CHANGE ORDER

No. One (1)

Contract: Dunleith Canal Bank Stabilization, Phase 4

Project: P081102-5

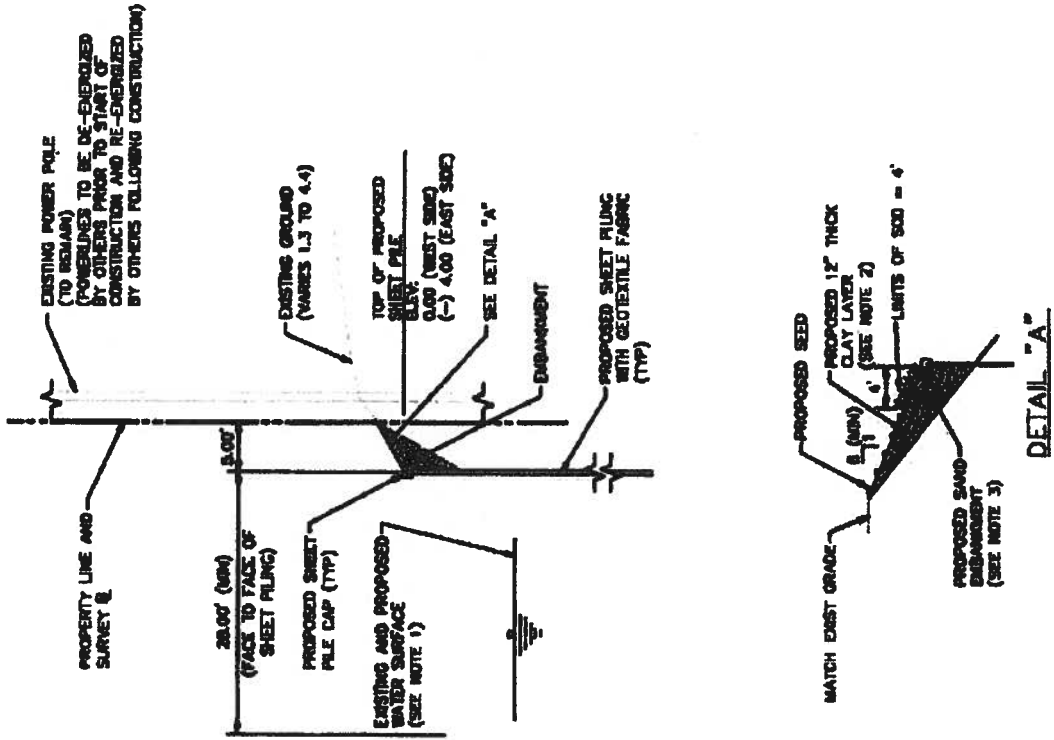
3. Please advise us of your communications with Shell Pipeline regarding the removal of canal fill materials in front of their bulkhead.
4. Please provide us change order pricing and timing for extending the sheet piling, backfill, and sod along west side of the Dunleith Canal south of the P.S. bridge from the south end of the straight run through Lot 70 to the end of the new turf reinforcement mat at the end of the Dunleith/Carriage Intersection project, a field-measured length of 104 feet. Also as part of this work, the end wingwall will be removed and placed at the end of the new run, 104 feet up the canal. Drawings and notes are attached for your convenience, which are the same drawings, specs, and details as the current plans.
